New Albany Board of Zoning Appeals Meeting Agenda
June 22, 2026, 6:30 p.m.

New Albany Board of Zoning Appeals
April 27, 2026 Meeting Minutes - DRAFT

**Board of Zoning Appeals Staff Report
April 27, 2026 Meeting**

LOCATION: 4326 Olmsted Road (PID: 222-001486-00)
APPLICANT: Memmer Homes c/o Megan Odenweller
REQUEST: Variance
ZONING: Single-Family Residential District (R-3)
STRATEGIC PLAN: Residential
APPLICATION: VAR-34-2026

Image: Plat showing easements and utility locations on and around the site. The rear yard is to the right/east.

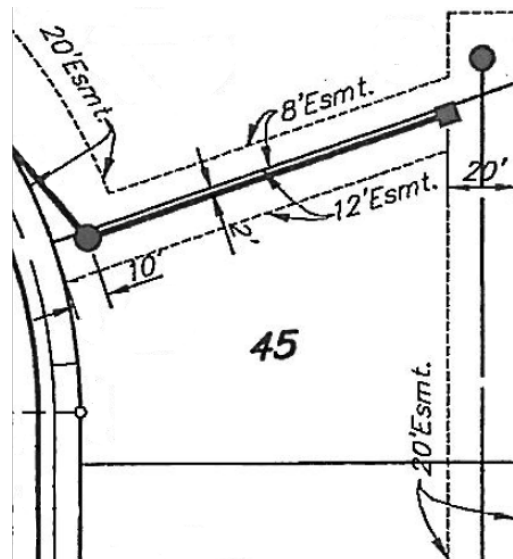
1. C.O. Section 1165.04(b)(3)(B) prohibits patios and other accessory structures from being located in an easement. The New Albany Links Section 1 plat shows a 20-foot-wide easement along the

rear (east) property line, which serves an underground sanitary sewer line that is approximately 10 feet into the property. The City engineer confirmed that there are public utilities within the easement.

Image: Project site plan highlighting the easement and encroachment.

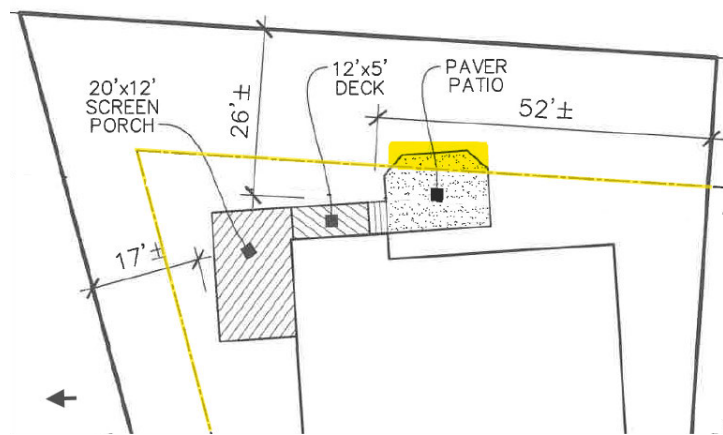
2. The applicant requests a variance to allow a paver patio to encroach approximately three feet into the aforementioned utility easement. The full paver patio is approximately 12 feet in length and 16 feet in width.

7. The variance has the potential to adversely affect the delivery of government services. Utility easements are intended to provide access to the utility, and any encroachment limits that access. However, paver patios are more easily removed than full decks or above-grade structures, and the patio does not appear to encroach over the underground utility line. Staff recommends a condition that no part of the patio be built over the underground utility line and no landscaping be installed within the easement (condition #2).

ARCHITECTURAL SITE PLAN

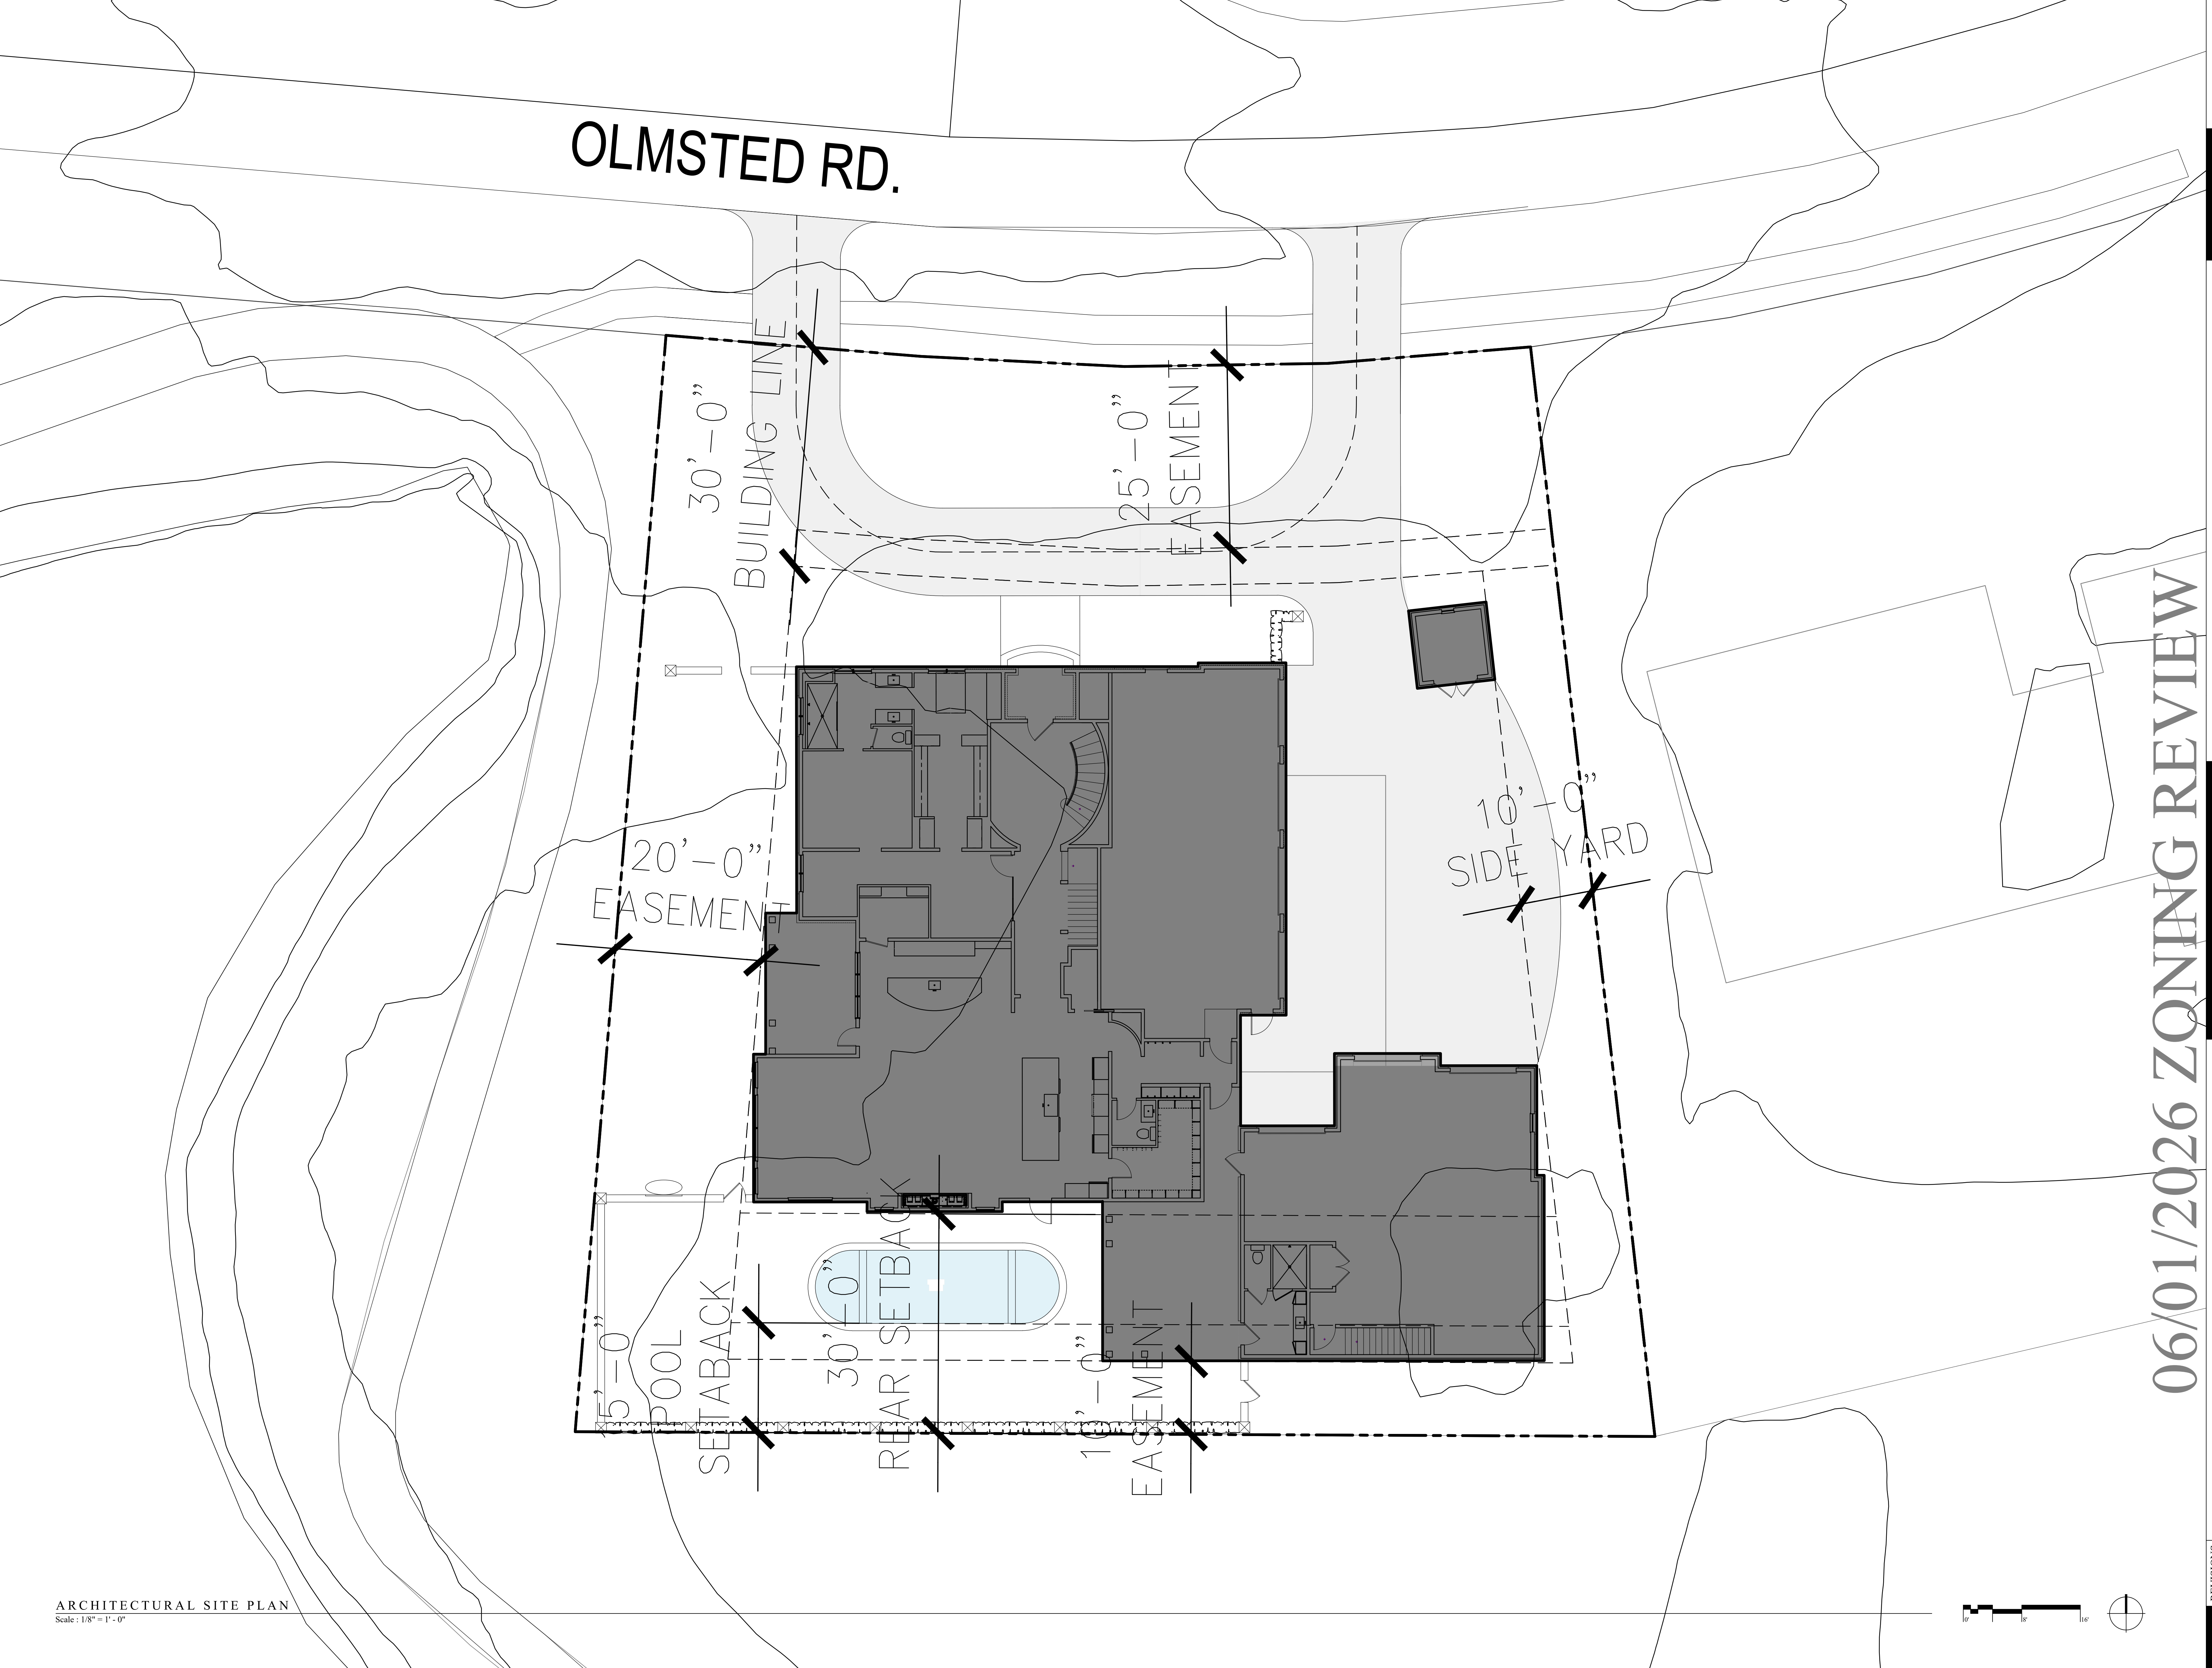
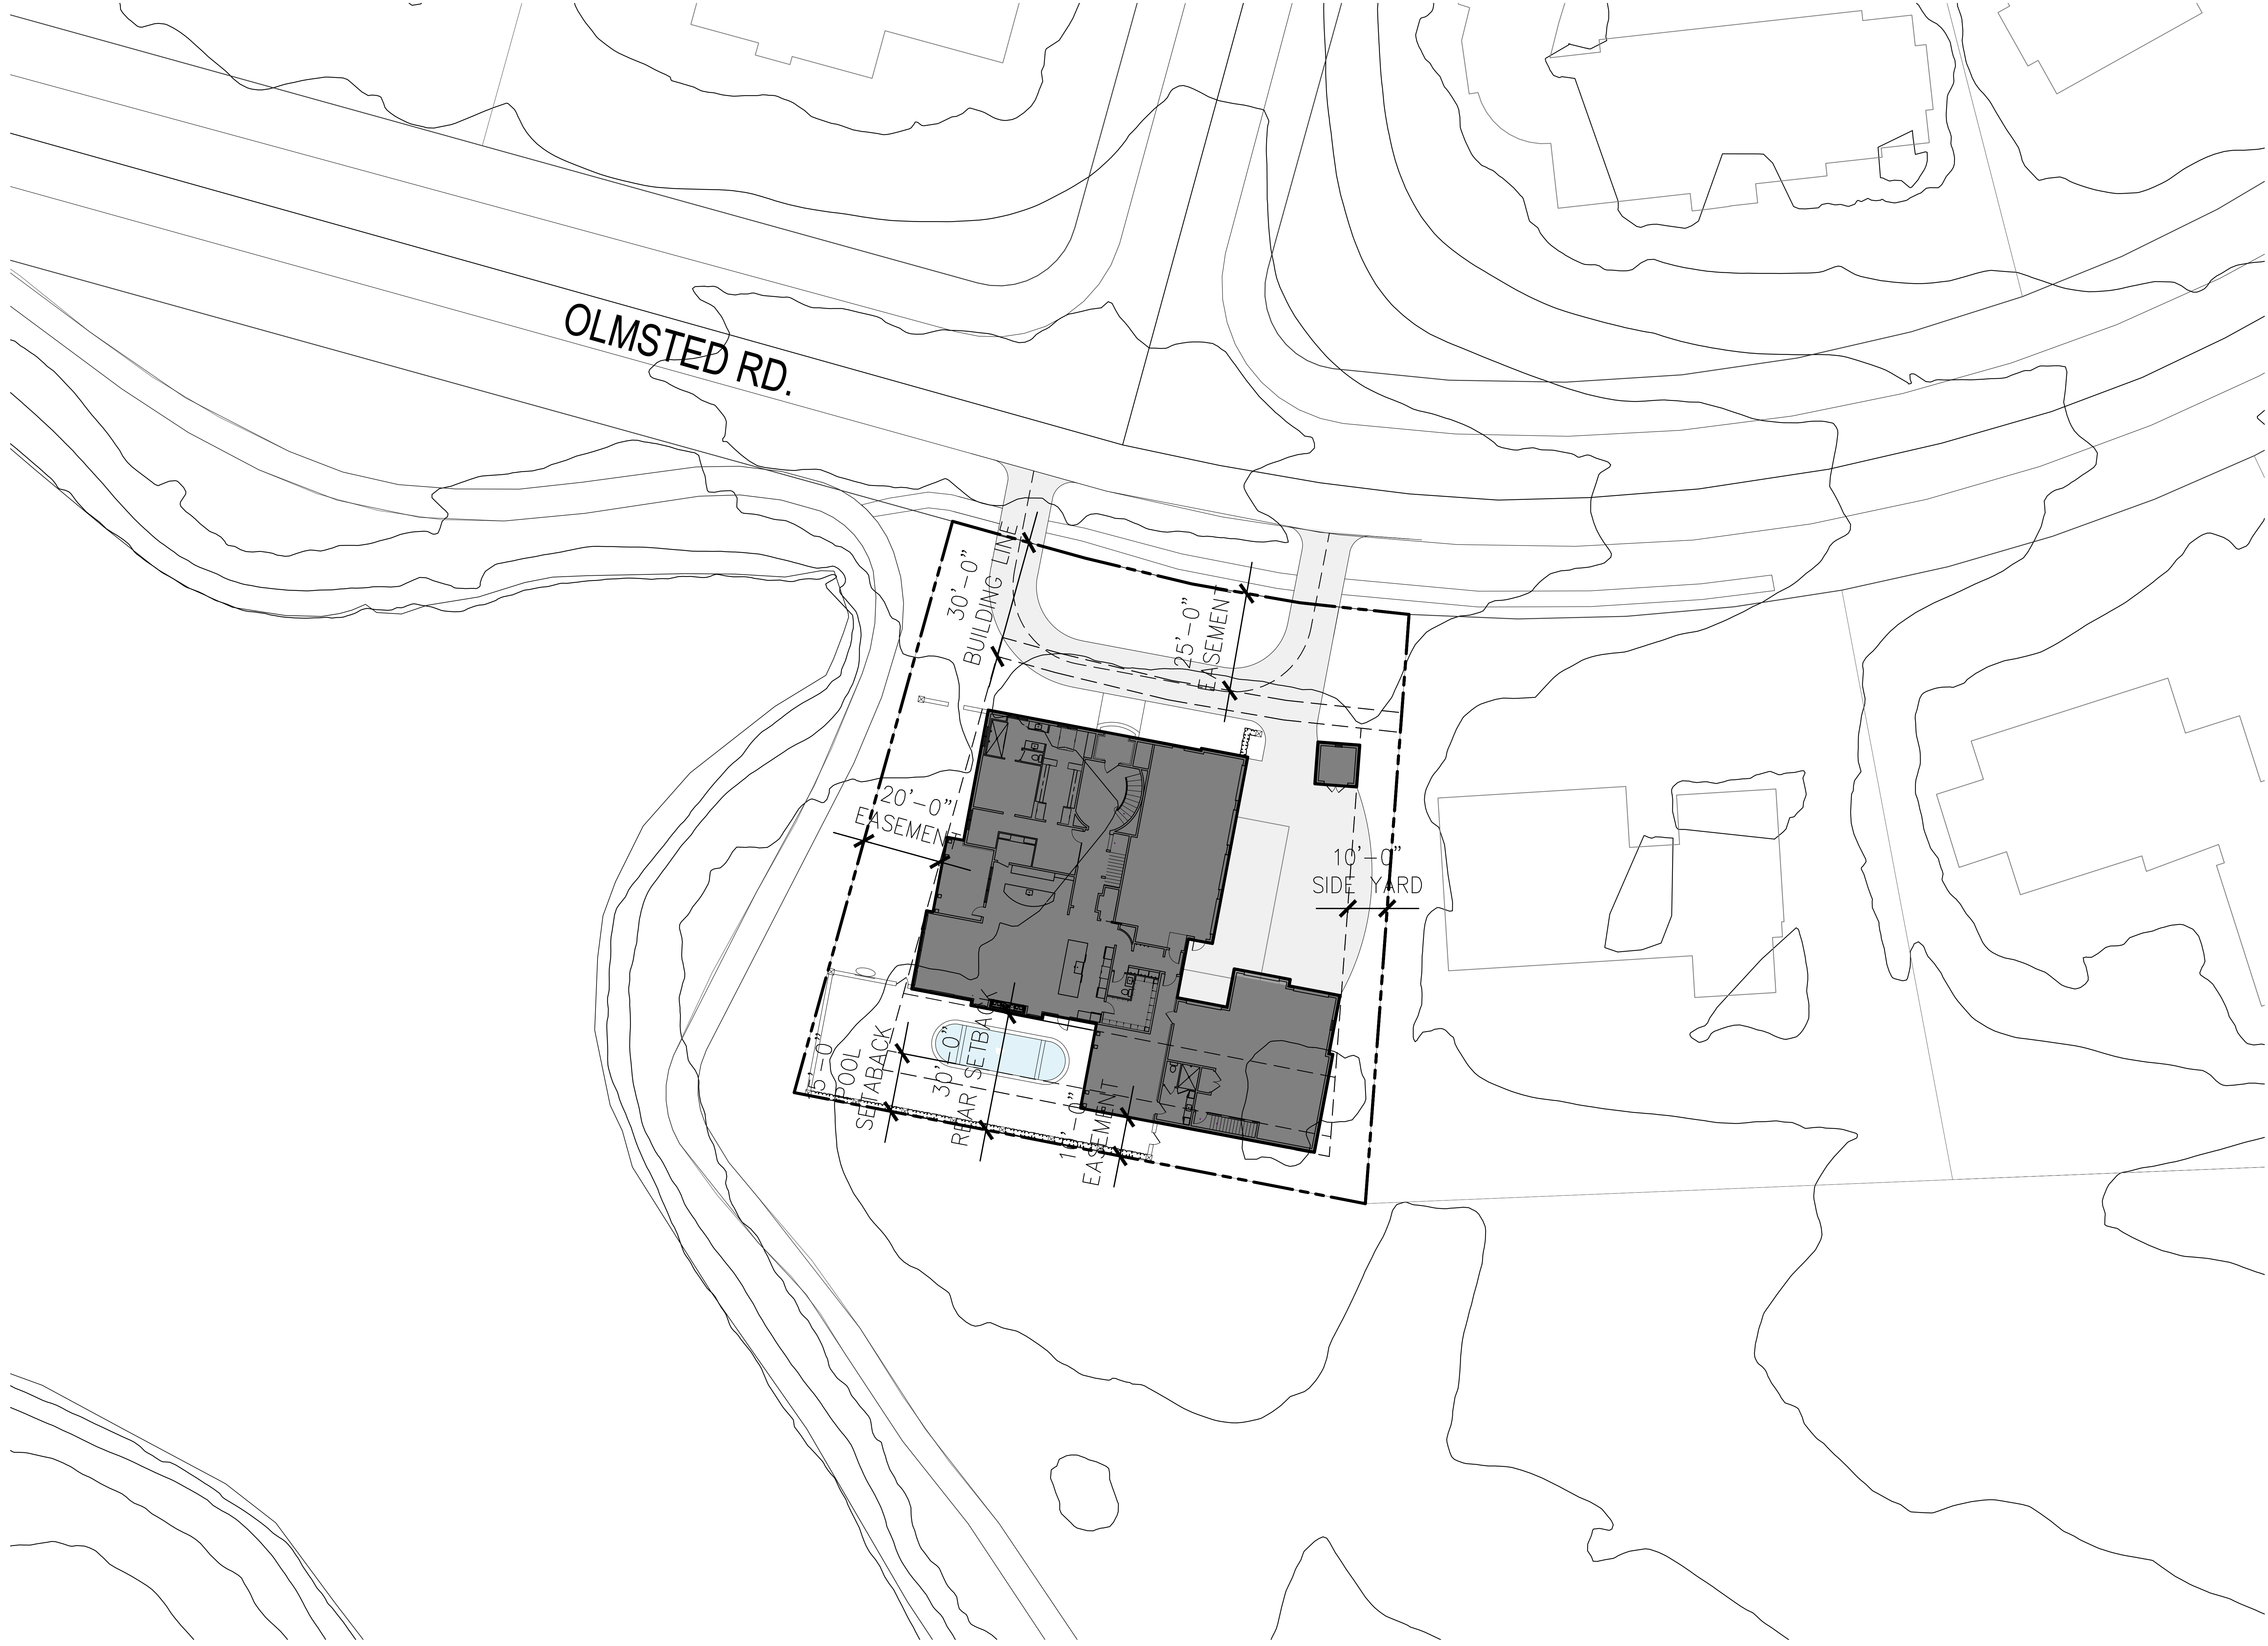
2. The applicant requests a variance to allow part of a new home to encroach 20 feet into the required 30-foot rear yard setback. The encroachment was originally proposed to be by a two-story detached garage and dwelling unit; as such, this structure is shown in some of the submitted application materials as detached. The applicant has stated that the structure will be attached to the main home, which makes it part of the primary structure, and shows this in site plans. Staff recommends a condition of approval that the detached structure be attached to the main home as shown in the site plan, subject to staff approval (condition #1). Additionally, the site plan shows:

- a. A pool in the rear yard. The applicant has stated that the pool is not part of this submittal and might be proposed in the future, at which time staff will verify it meets zoning requirements.

- b. A 100-square-foot enclosed structure, identified as a gatehouse, near the front of the site. Accessory structures are not permitted to encroach into the front yard. Staff will verify that the gatehouse is, at a minimum, aligned with the front façade of the main structure at the time of permitting.

1. The detached structure shall be attached to the main home as shown in the site plan, subject to staff approval.
